Pre-Application Meeting Summary Notes

25.01.2023

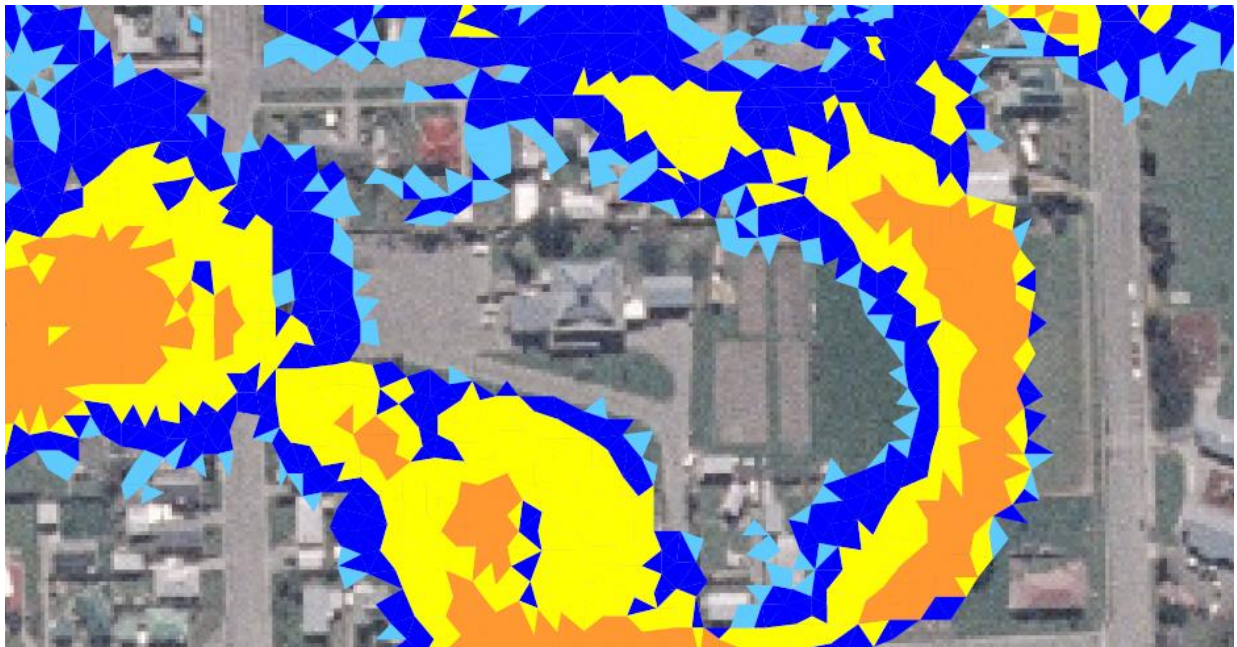
Preliminary assessment of floor levels required to address internal network flooding risk. See below excerpt of the site from GDC Flood Mapping for a 1 in 100 year flood event – Based on this GDC suggest a minimum floor level of 73.3 – (approx. 300 mm above the current ground level for most of the site, refer second screen shot of contour levels for the site) - this can potentially be refined further.
